City of Detroit
Inter-Departmental Communication

RE: Petition No. 1397
Request to Convert to Easement North/South Alley in The Block Bounded East
Warren, Seyburn, Van Dyke, East Forest

NOTICE OF PROPOSED CHANGE IN PROPERTY

B					REQUEST TO CONVERT TO EASEMENT THE NORTH/SOUTH PUBLIC ALLEY, 20 FT. WD. IN THE BLOCK BOUND BY E. FOREST, SEYBURN, E. WARREN AND VAN DYKE AVE.	CITY OF DETROIT CITY ENGINEERING DEPARTMENT SURVEY BUREAU
	A					
DESCRIPTION		DRWN	CHKD	APPD	DATE	JOB NO. 01-01 DRWG. NO. X 1397
REVISIONS						
DRAWN BY	WLW	CHECKED				
DATE	03-20-17	APPROVED

LATERAL SEWER IN ALLEY

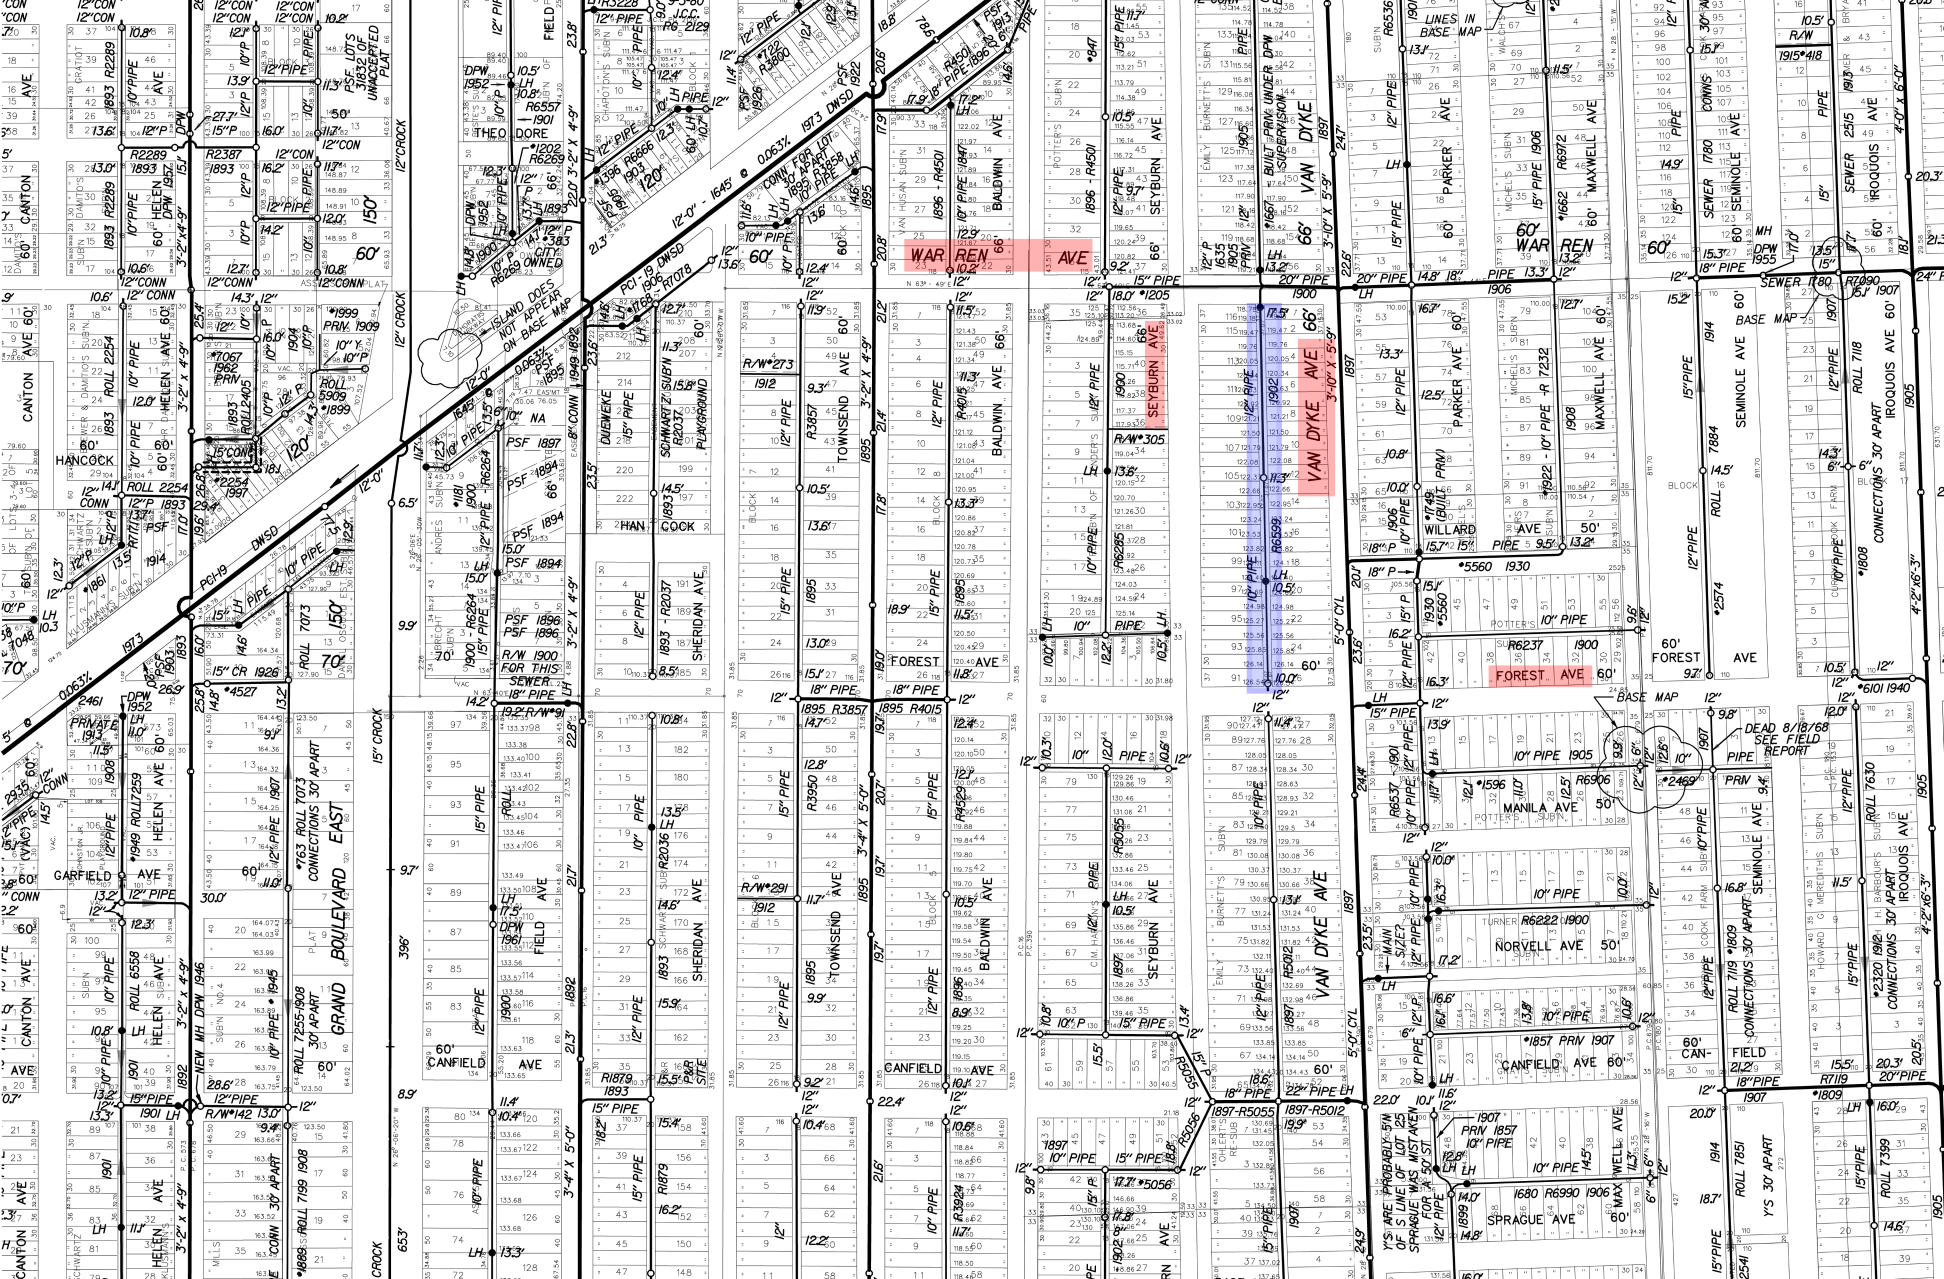
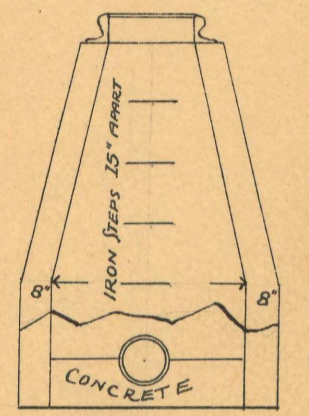
- Our records indicate that there is sewer in the alley. DWSD has no objection to the requested conversion to easement provided that the attached Provisions for Conversion to Easement are strictly followed.

1. An easement, the full width of the existing right of way, is reserved for the Detroit Water and Sewerage Department for the purpose of installing, maintaining, repairing, removing, or replacing any sewers, water mains, fire hydrants and appurtenances, with the right of ingress and egress at any time to, and over said easement for the purpose above set forth.

2. Said owners of the adjoining property, for themselves, their heirs and assigns, agree that no building or structure of any nature whatsoever, including fences, porches, patios, balconies, etc., shall be built upon or over said easement, or that no grade changes or storage of materials shall be made within said easement without prior written approval and agreement with the Detroit Water and Sewerage Department.
